L-PI-03-003

**PRAIRIE ISLAND NUCLEAR GENERATING PLANT**  
Docket No. 50-282 License No. DPR-42

**Core Operating Limits Report (COLR) for Prairie Island Unit 1 Cycle 22, Revision 0**

**UNIT 1 – CYCLE 22**

**Figure 2a: Bounding V(z) Values  
From 0 - 4.000 GWd/MTU  
(Startup)**

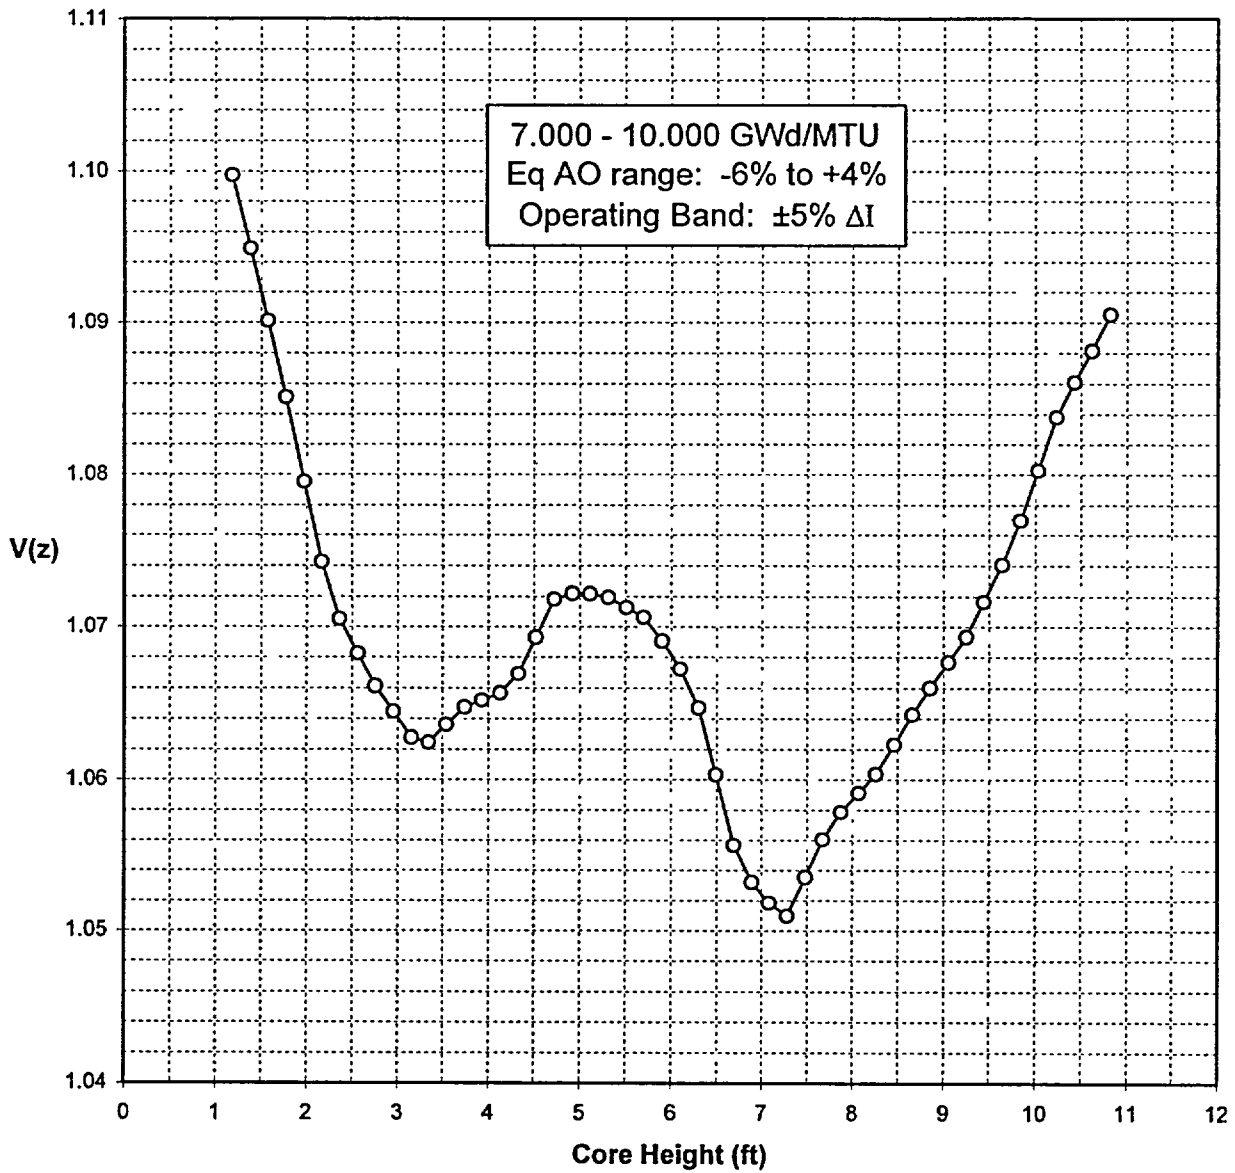
- Tables 1 and 2 have been updated to incorporate revised bounding V(z) values.
- Table 3 has been updated to incorporate revised minimum shutdown margin limits.
- Figures 2a through 2f have been updated to incorporate revised bounding V(z) values.
- New Figure 2g has been included with additional bounding V(z) values.
- Text has been deleted or revised to eliminate duplication with the Technical Specifications and Bases.
